Firmware Updates Information 12.07.2012

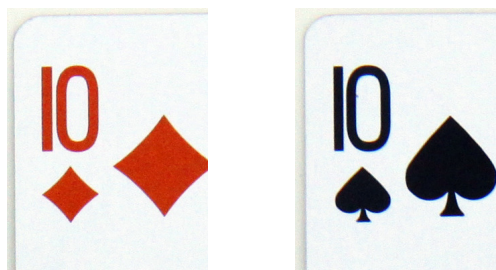
- Corrected recognize cards when something is touching the symbol on the right side:

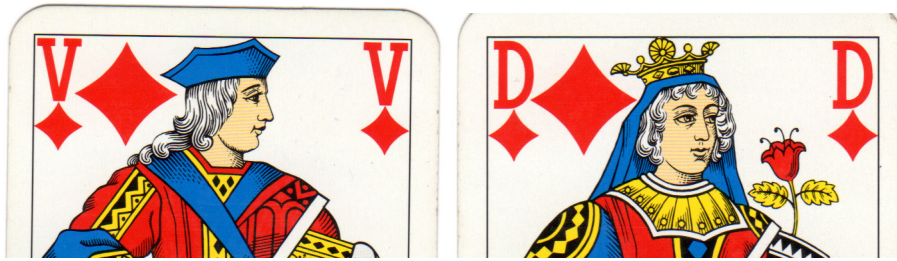
- Improved algorithm for cards with outside frame
- Changed recognition algorithm for cards when card index touches inside frame

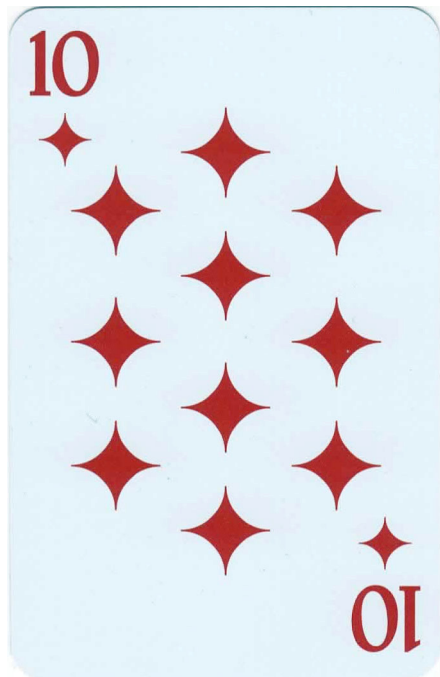
- Corrected problem with club recognition for Japan Nintendo Cards:
